NANT YR ABER REVETMENT REPAIR 2019, DECAY UPDATE JANUARY 2025.

Project title: Foot Path 55 Nant yr Aber Caerphilly

Drawing title: River Bank Reinstatement

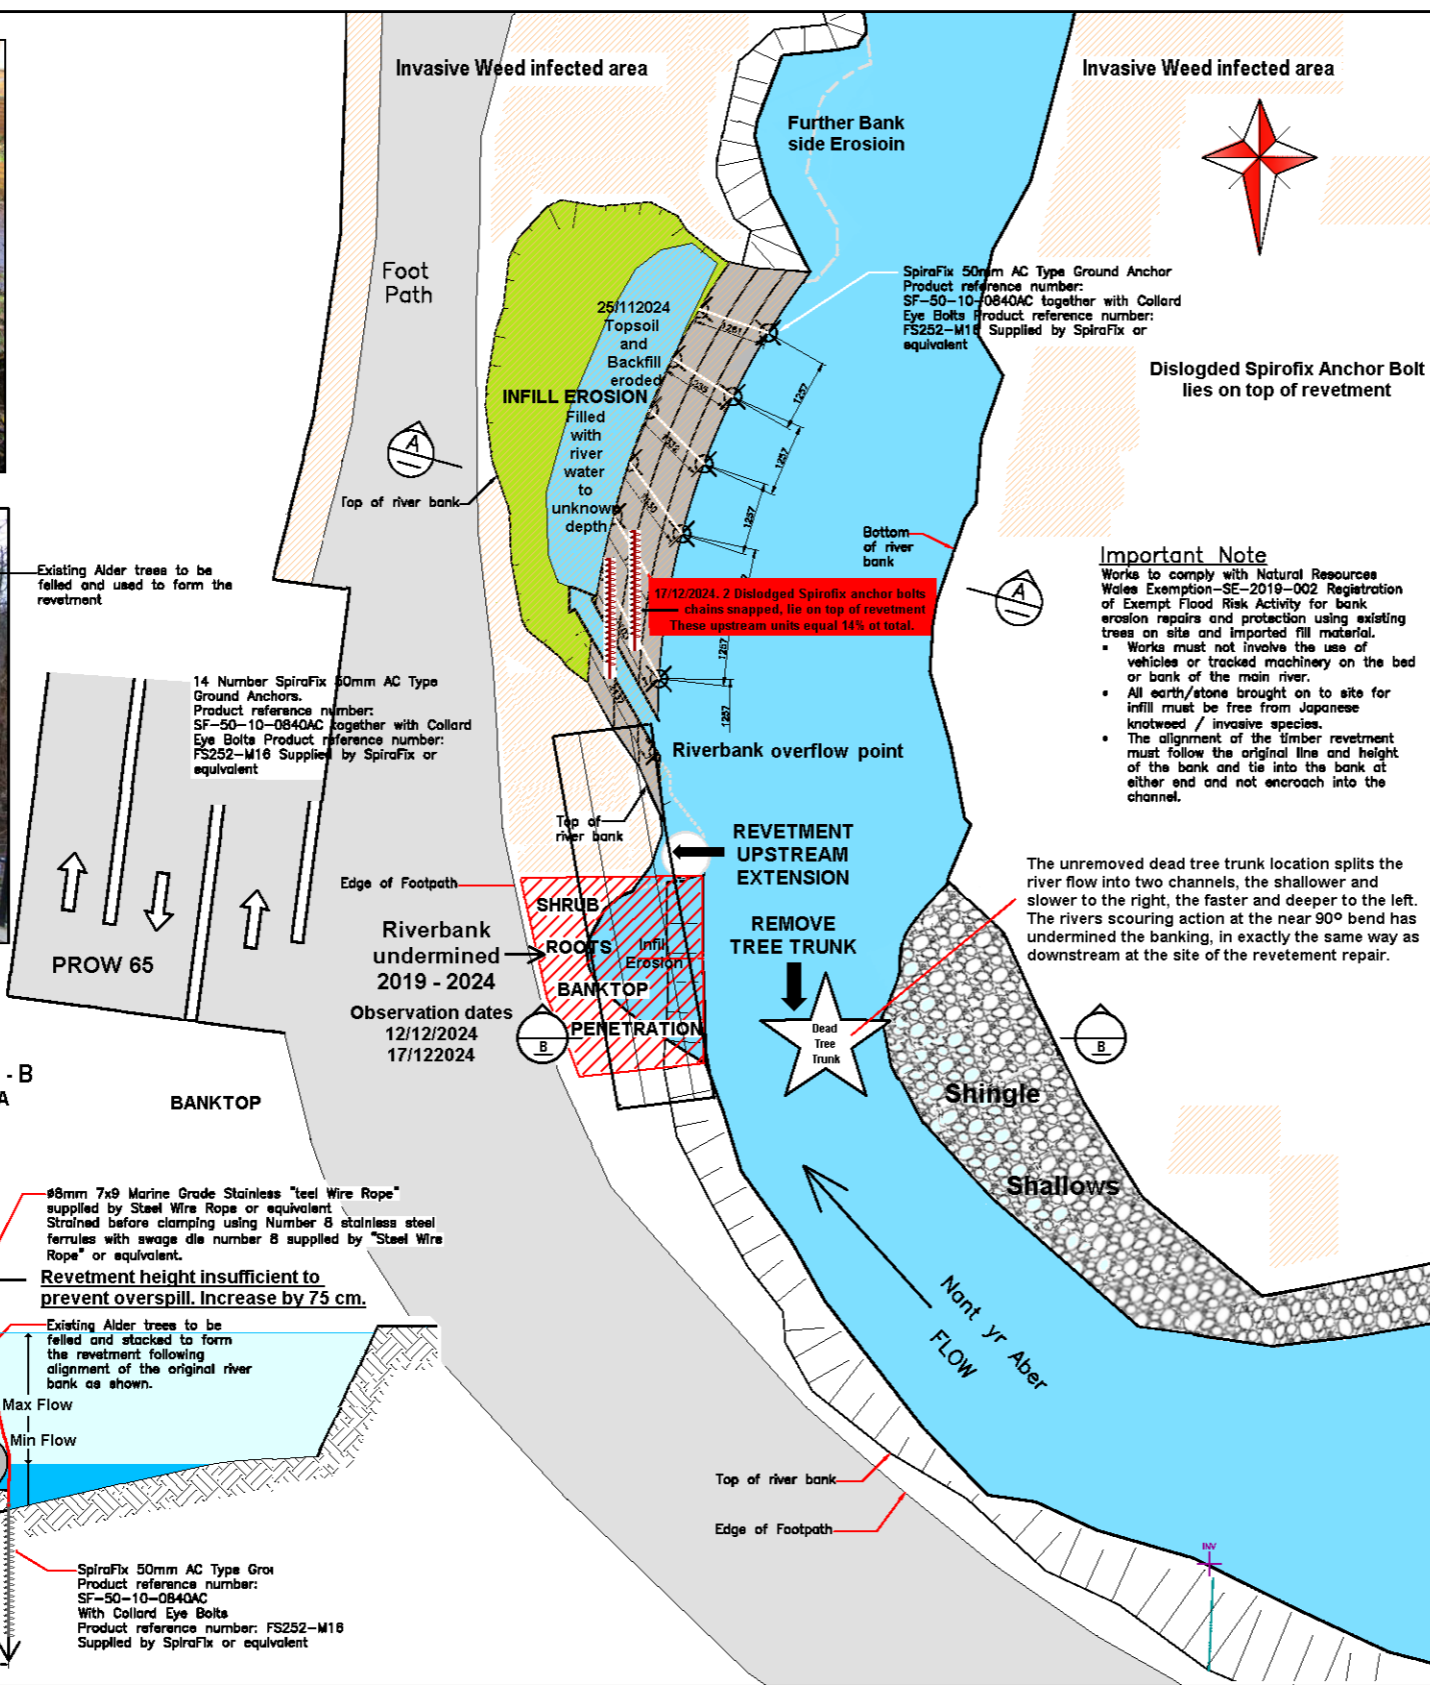
- Indicators are always present, but if not understood will aggravate planned resolution outcomes.
- The CCBC revetment repair plan drawing alongside reveals errors that were not foreseen or adequately taken into consideration.

1. The western bank side is on a near 90° bend of soft marl that does not appear to have been taken into account, nor the effects of bank side root penetration.

2. Or the presence of a mid stream dead tree trunk affect on river water flows.
 3. Plus the overall length and height of the revetment repair to repel river overflow.

4. The security of the anchor bolts used. 14% now failed, places increased pressure on the remaining anchor bolts.
 5. For these reasons there is now a need to extend bank side revetment upstream by both height and length.

6. These failings may regrettably increase without proactive input from Natural Resources Wales and CCBC corrective remedial action undertaken to rectify all the underlying causes, as far as the downstream Gallagher Park retail estate that includes the removal of the Dead tree trunk and the Aldi store's site drainage construction across the INMC 64 footpath by CAB or CJB builders, that resulted in bank side stones each approx 1m⁽³⁾, left as debris in the river bed to negatively affect the river flows path.

The amended plan above indicates the failings that have arisen in the five years following completion of the revetment repair.

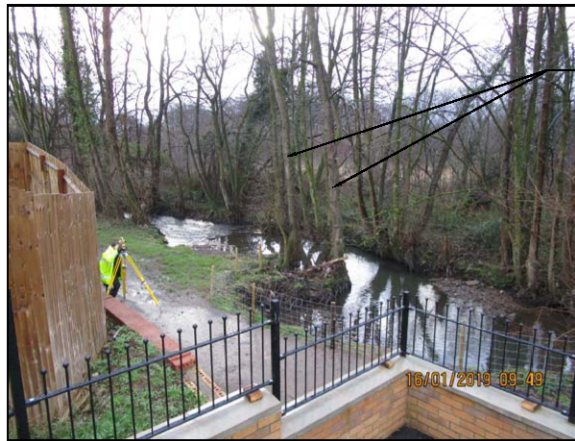
In the picture above the central white arrow shows evidence of the riverbank side's marl type of soil, is constantly undermined from the increased river flow forced by dead tree trunk.

That erosion extends around 1000mm backwards under the surface vegetation growth, whose roots dangle down through the eroded bank into the river water, weakening the bank side structure next to the public footpath.

The rate of erosion becomes more intense after heavy rainfall that increases the rivers depth and metres per second flow speed.

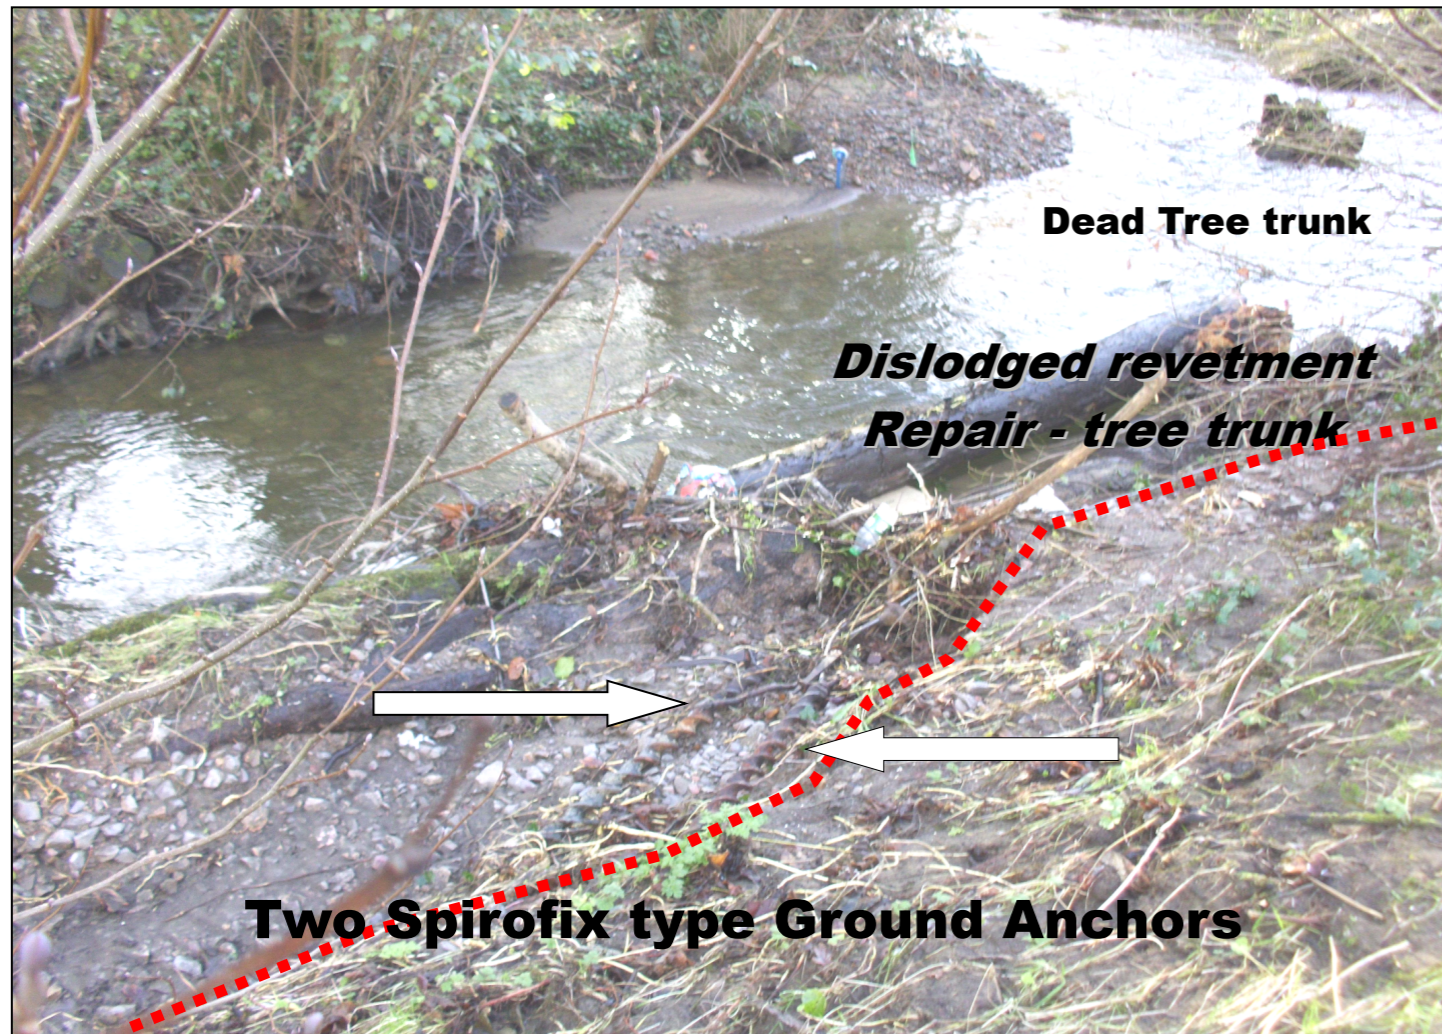
To the left of the hatched red line in the picture above, shows evidence of the river revetment bank exposure and backfill erosion depth of around 80cm, of the certified weed free soil plus backfill material.

It would appear that the '*Dislodged revetment repair tree trunk*' that had lain across the river, has been manoeuvred back alongside and re-strapped to the repair.

The two white arrows point to the two of the Spirofix type revetment ground anchor bolts dislodged by the erosive action of the Nant Yr Aber River. Zoom in for clarity.

On the right of the red hatched line, on remaining foreground soil, the over winter dead stalks of Himalayan balsam spread lie flattened from the constant river overflows, where the 2019 planned bank side repair which was then, and even now is still to low.
